# CONSTRUCTION STORMWATER COMPLIANCE INSPECTION REPORT

State of Washington Department of Ecology

Water Quality Name and Location of Site Inspected: Stetson Heights Northwest of Glenwood Rd SW & SW Sedgwick Rd Port Orchard, WA 98367	GPS Lat: 47.497034 Long: -122.661325	Entry Time 9:40 am Exit Time 1:50 pm
On-Site Representative Name: Robert Terhune Title: Phone: (253) 561-1569 Email:		Additional Participants: Craig Jordan & Tom Satterthwaite with Dam Safety

Photo 6 Description: The channels to pond between the two eastern ponds have rock check dams, but are not lined.

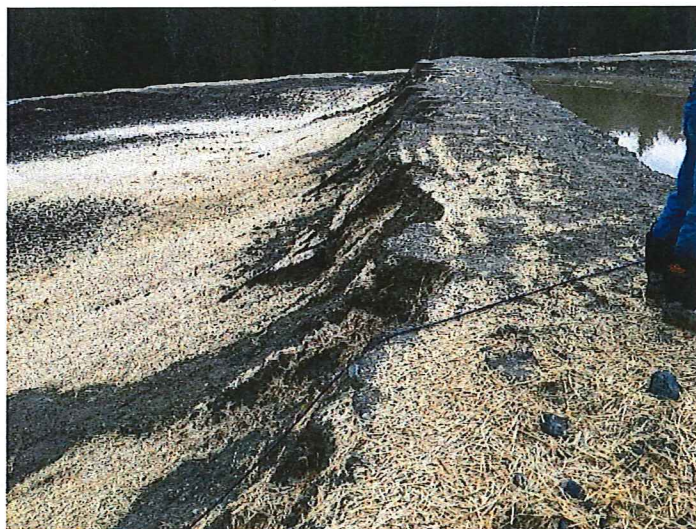
**The site is in violation of permit condition S9.D.8.a. for failure to stabilize channels.** Stabilize all on-site conveyance channels to prevent erosion. **This must be corrected within 7 days of the date you receive this document.**

Photo 11 Description: Slope above wetland needs to be stabilized.

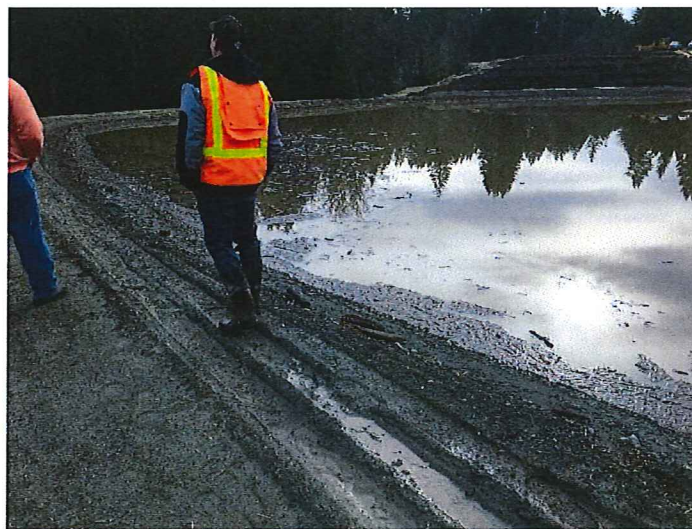
**The site is in violation of permit condition S9.D.5.d. for failure to stabilize all exposed and unworked soils within 2 days between October 1 and April 30.** Unworked soils must be stabilized or protected with a BMP like a seeding, mulching, plastic covering, or erosion control fabrics. **This must be corrected within 2 days of the date you receive this document.**
